**In The Drawings:**

**REMARKS****Introductory Comments:**

Annotation Marked-up Drawings Application No. 10/707,501

**FIG. 1**

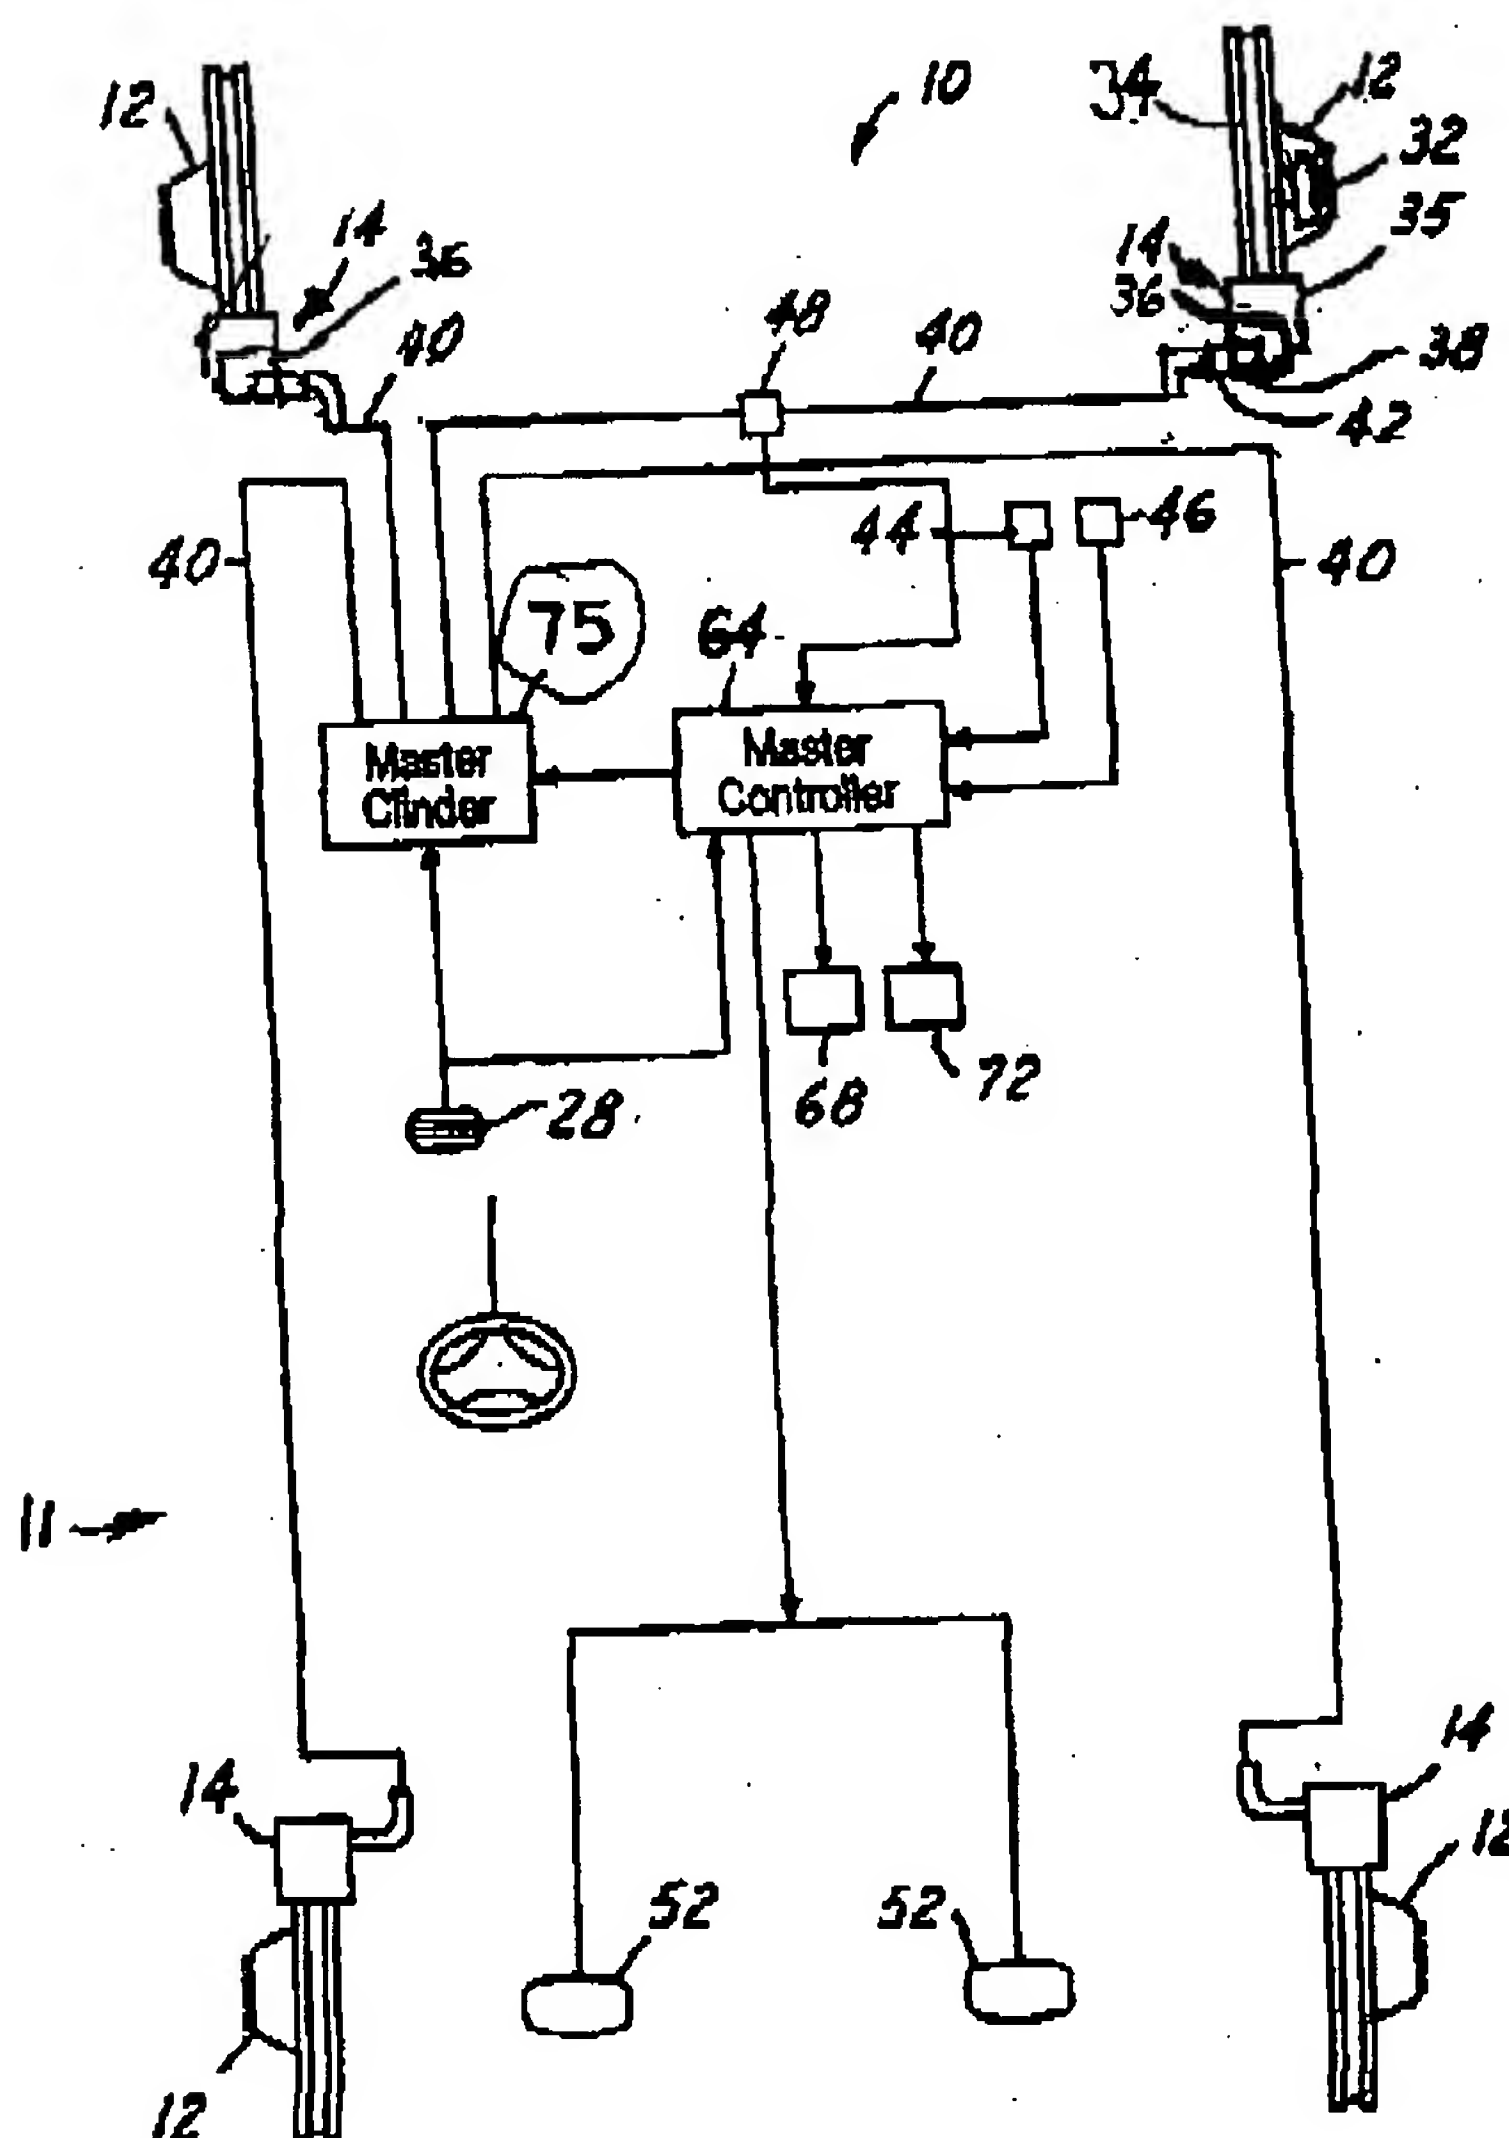
Regarding the drawing objections discussed in paragraph 1 of the Office Action, Applicants have amended the drawings in accordance with the Examiner's suggestions and have further amended paragraphs [0019] and [0026] of the Detailed Description of the Preferred Embodiment such that numbers in the amended drawings are clearly represented therein. No new matter has been added. Applicants therefore submit two Replacement Sheets containing Figures 1, 1A, 1B, and 1C.

Please substitute the two sheets of drawings submitted herewith containing Figures 1, 1A, 1B, and 1C in place of the originally filed drawing sheets containing the same Figures.
